April 15, 2009  
NND-09-0076

Subject: Virgil C. Summer Nuclear Station (VCSNS) Units 2 and 3 Combined License Application (COLA) - Docket Numbers 52-027 and 52-028 Response to NRC Request for Additional Information (RAI) Letter No. 033

**NRC RAI Letter No. 033 Dated February 12, 2009**

**SRP Section: 2.5.1 – Basic Geologic and Seismic Information**

Figure 2.5.1-218 Local Charleston Tectonic Features

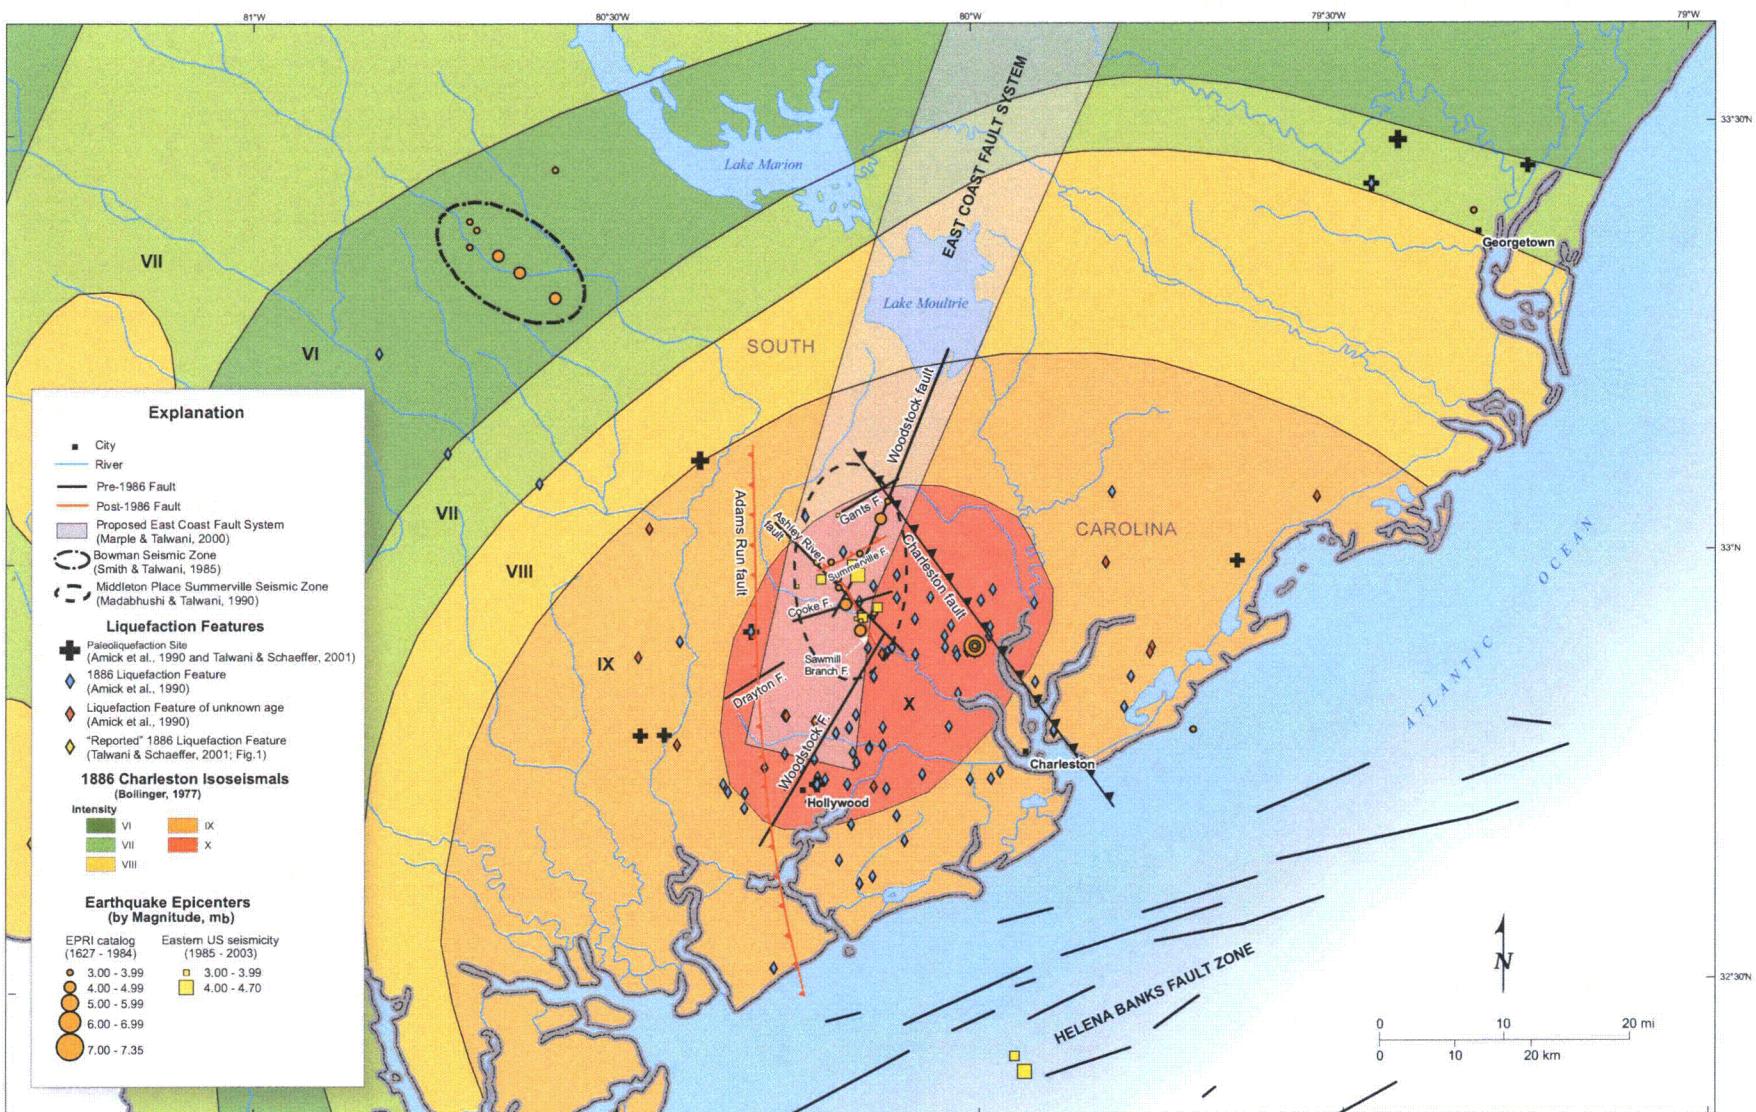
FSAR Section 2.5.1.1.3.2.1 describes potential source faults in the Charleston area, including the postulated Sawmill Branch fault (pg 2.5.1-37). FSAR Section 2.5.1.1.3.2.1 (page 2.5.1-37) states that the Sawmill Branch fault trends northwest, but the fault is shown with two different strike directions: a northwest strike on Figure 2.5.1-219 and a northeast strike on Figure 2.5.1-218. Furthermore, FSAR Section 2.5.1.1.3.2.1 indicates it is a segment of the Ashley River fault and offsets the Woodstock fault. However, Figure 2.5.1-219 shows it crossing the Ashley River fault while Figure 2.5.1-218 shows that it intersects, but does not cross or offset, the Woodstock fault.

In order for the staff to assess the hazard potential of the Sawmill Branch fault, please provide a corrected figure to illustrate location, orientation, and cross-cutting character of this fault. Please also discuss the proposed Dorchester fault, locate this structure on the appropriate map, and clarify the interpreted relationships between the Sawmill Branch, Ashley River, Woodstock, and Dorchester faults taking into account information presented in the recent literature.

The depictions of faults near Charleston, South Carolina shown in FSAR Figures 2.5.1-218 and 2.5.1-219 are identical, with the exception that the latter figure shows a close-up view of the 1886 meizoseismal area. The apparent discrepancy in the strike of the proposed Sawmill Branch fault between these two figures is the result of misleading

cartography. In FSAR Figure 2.5.1-218, the reviewer has misinterpreted a leader-line pointing to the Sawmill Branch fault for the map depiction of the fault itself. FSAR Figure 2.5.1-218 will be modified to correct this potentially confusing leader-line.

FSAR Figure 2.5.1-218 will be replaced with the attached revised Figure 2.5.1-218 (Attachment 5) to correct a potentially confusing leader-line pointing to the Sawmill Branch fault.

Figure 2.5.1-219 Charleston Area Seismicity

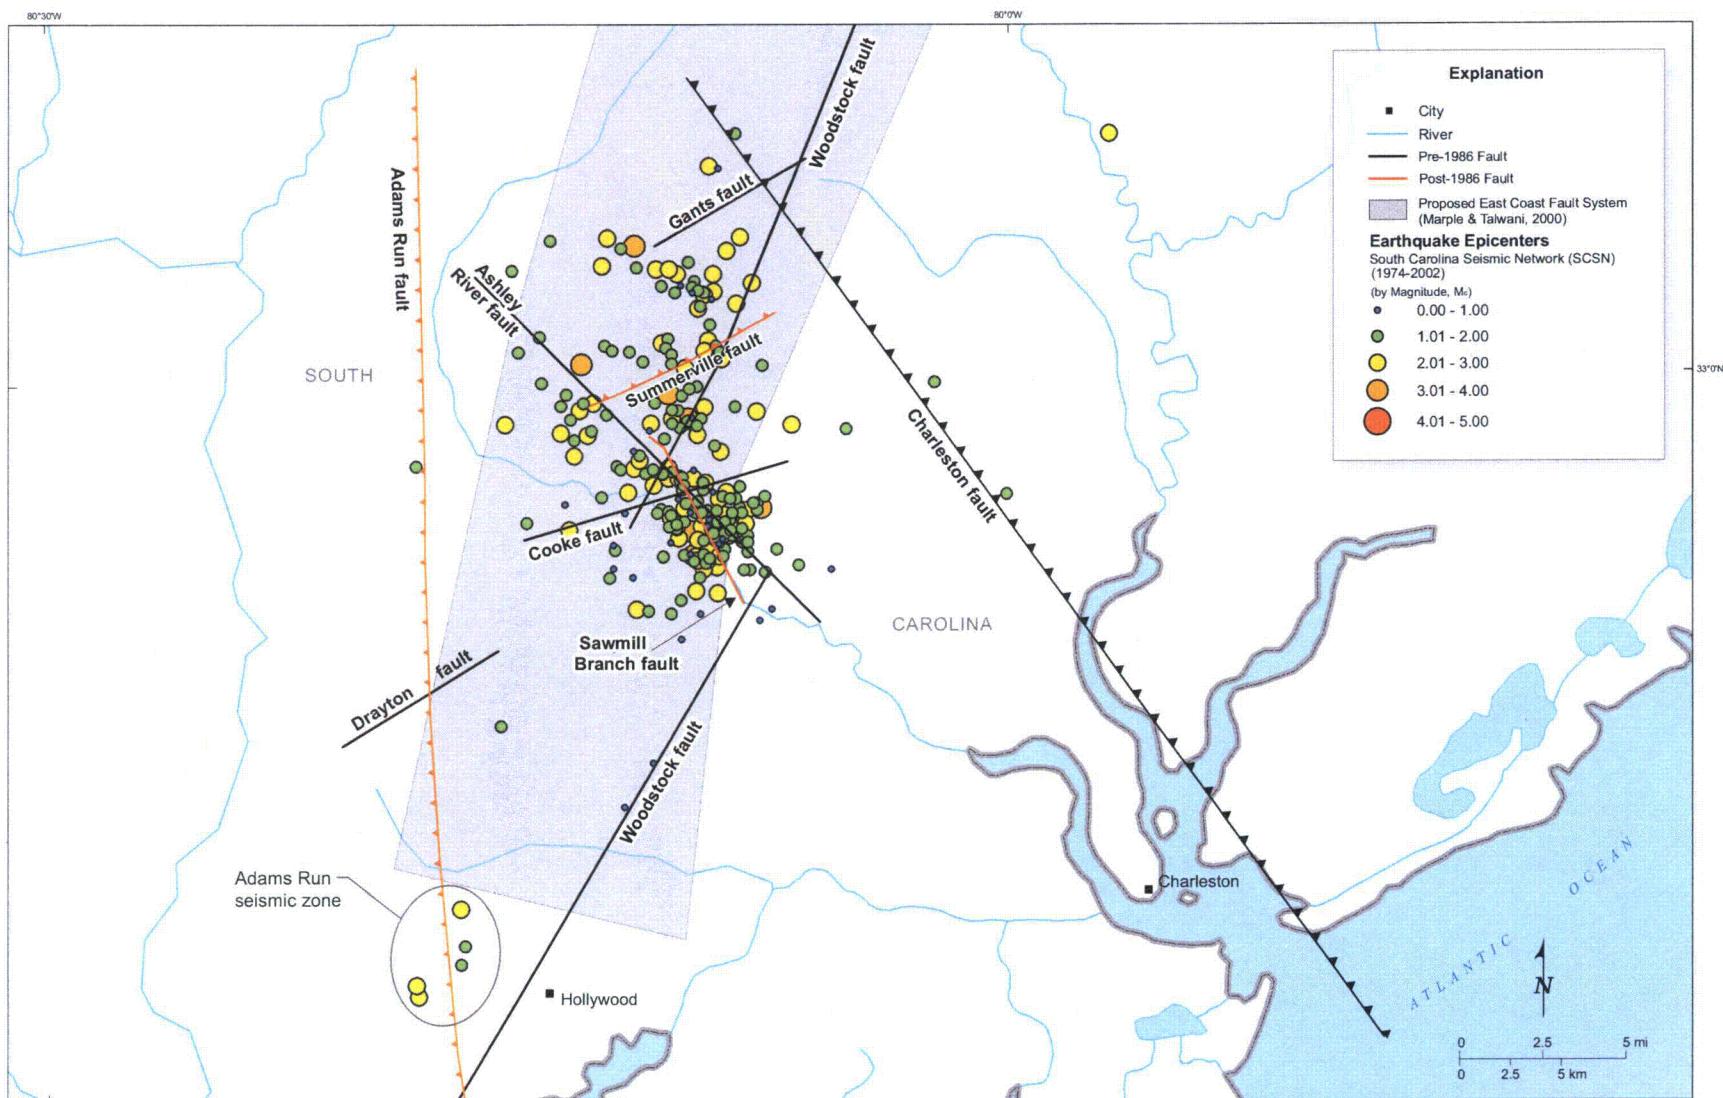
FSAR Section 2.5.1.1.3.2.1 (page 2.5.1-38) discusses the Adams Run seismic zone and cites Figure 2.5.1-219 as showing the location of this zone. The Adams Run seismic zone is not labeled in Figure 2.5.1-219, although the Adams Run fault, which is separately discussed in FSAR Section 2.5.1.1.3.2.1 (page 2.5.1-33), is located on that figure. Neither discussion directly relates the seismic zone to the fault, although they appear to be the same feature.

In order for the staff to assess the hazard potential of the Adams Run seismic zone and understand the specific relationship of this zone to the Adams Run fault, please clearly define the relationship between these two features which are currently discussed separately and locate the seismic zone relative to the fault on the appropriate figure(s).

FSAR Subsection 2.5.1.1.3.2.1 will be revised to describe in greater detail the earthquakes of the Adams Run seismic zone. FSAR Figure 2.5.1-219 will be revised to show the location of the Adams Run seismic zone.

3. FSAR Chapter 2, Figure 2.5.1-219 will be replaced with revised Figure 2.5.1-219 (Attachment 6) to show the location of the Adams Run seismic zone.
